1954 Corvette: Service Bulletin: Connecting Rods

Subject: Connecting Rods

Bulletin No: DR-164

Date: January 13, 1954

AFTER **BEFORE**
REWORKING 1953 POWERGLIDE ROD FOR
USE IN 1954 POWERGLIDE ENGINE

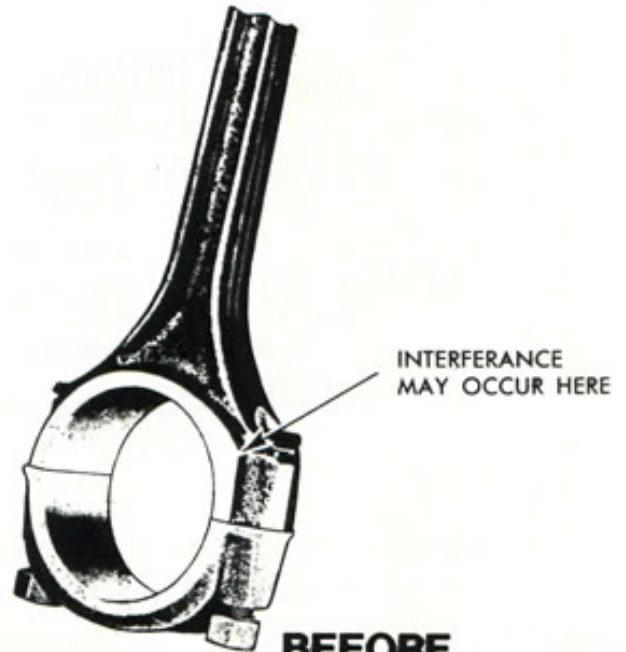
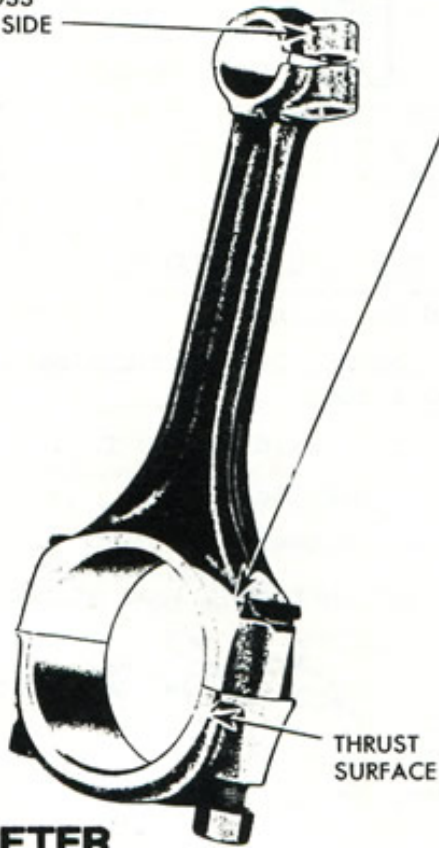
Until such time as the 1954 Passenger Car Powerglide Connecting Rods are available and it is necessary to replace a rod in a 1954 Powerglide Engine, the 1953 Powderglide Rod may be used after reworking.

if the 1953 Rod is not reworked, interference may occur between the new wide lobed (9/16") camshaft and the number 2, 4 and 6 rods on the camshaft side at the rear of the rod in the area at top of connecting rod bolt.

PINCH BOLT BOSS
TO CAMSHAFT SIDE

RELIEVE THIS AREA
BY GRINDING AS SHOWN.
GROUND AREA SHOULD BE
AT 30° WITH THRUST SURFACE
OF ROD-CAMSHAFT SIDE-REAR
ON NO. 2, NO. 4, NO. 6 RODS
